HIGHWAY WORK PROPOSAL

Proposal Number: **011**

| <u>COUNTY</u> | <u>STATE PROJECT</u> | <u>FEDERAL</u> | <u>PROJECT DESCRIPTION</u> | <u>HIGHWAY</u> |
|---------------|----------------------|----------------|---|----------------|
| Douglas | 8510-01-70 | N/A | Port Wing - Superior; Cth H To Engdahl Road | STH 013 |

Addendum No. 01
ID 8510-01-70
Revised Sheet 2
September 29, 2022

Addendum No. 02
ID 8510-01-70
Revised Sheet 15
October 6, 2022

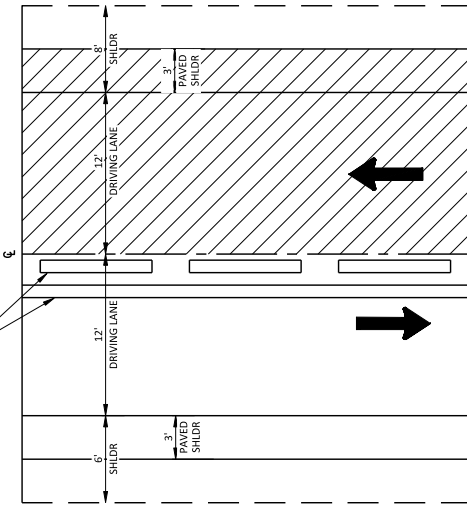
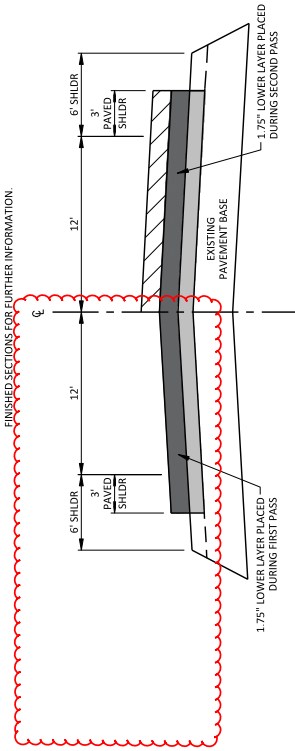
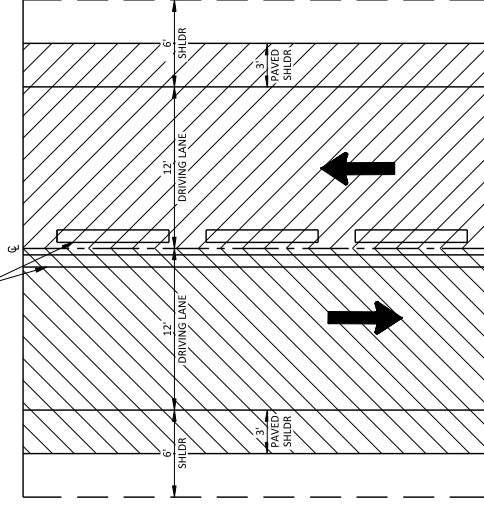
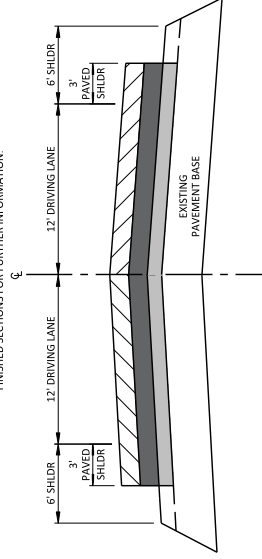
| Revised Plan Sheets | |
|---------------------|---|
| 15 | Construction Details: Paving Sequence of Operations; Removed Longitudinal Wedge Joint |
